**SUBJECT: TRAFFIC METHODOLOGY APPROVAL LETTER**  
PROJECT NAME: ENCLAVE HOUSING CR 42 TRAFFIC IMPACT STUDY  
PROJECT #2025010062 APPLICATION: #32409 PARCEL #47667-004-00

Project: Enclave Housing CR 42

Subject: Proposed Methodology for Enclave Housing CR 42

RE: Enclave Housing CR 42 Response to Comments

Figure 2. Project Trip Distribution

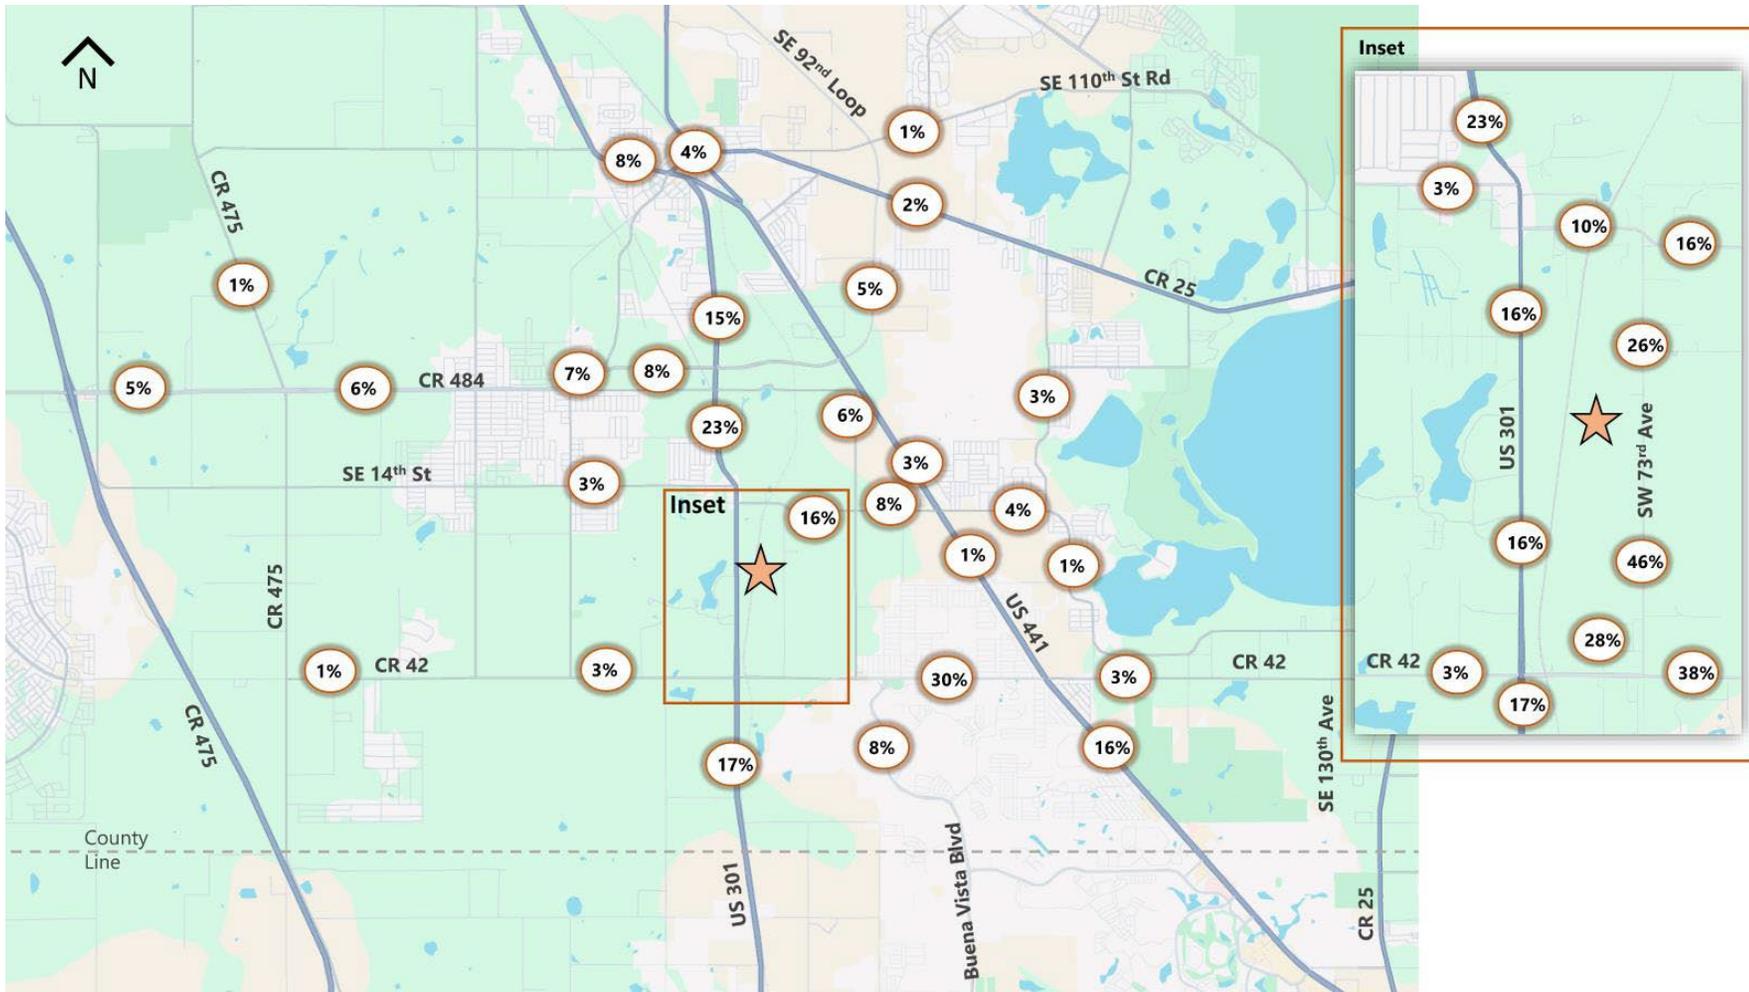
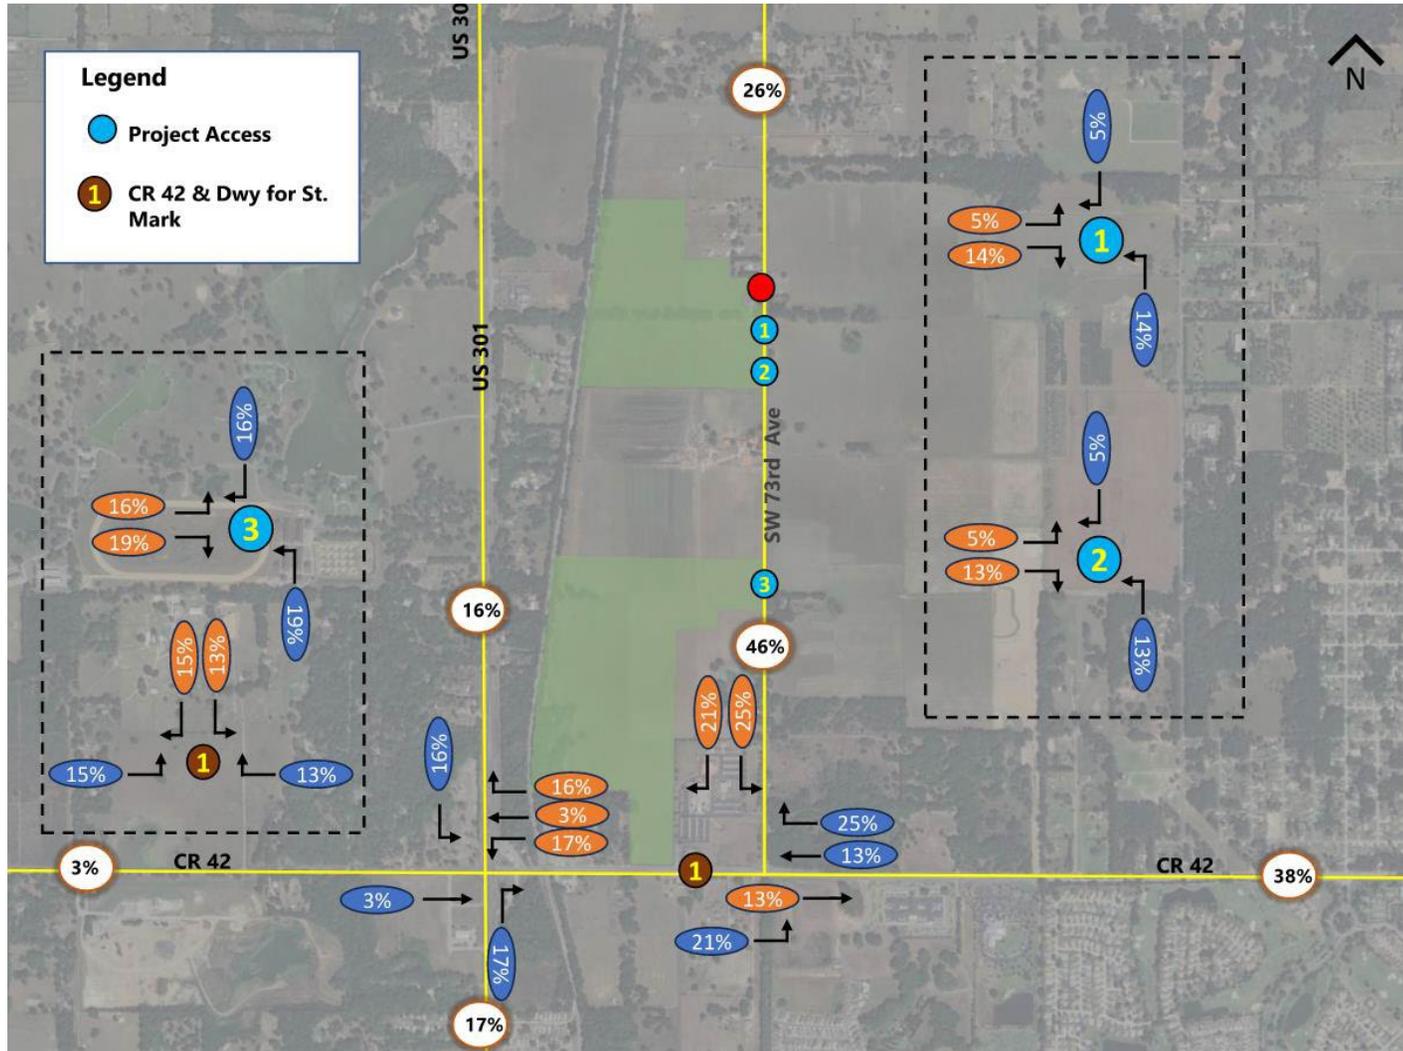
2. PDF pg. 4 & 5, Figures 2 & 3 - Figures 2 & 3 show different distributions to/from the south on SE 73rd Ave. Figure 2 shows 54% while Figure 3 shows 39%. Update the figures to show the same distributions on SE 73rd Ave. Ensure the distributions used in Table 2 also match the distributions shown on Figures 2 & 3.

***Response: Agreed, and Figures 2 & 3 are updated accordingly.***

4. PDF pg. 5, Figure 3 - The 39% to/from the south on SE 73rd Ave needs to be changed to 46% based on the distributions shown at the driveways on SE 73rd Ave

5. PDF pg. 5, Figure 3 - The 15% of eastbound through traffic on CR 42 at SE 73rd Ave needs to be changed to 13%.

***Response: Figure 3 has been updated to show 46% to/from the south on SE 73rd Ave.***

***Response: Figure 3 has been updated to show 13% eastbound through traffic on CR 42 at SE 73rd Avenue.***
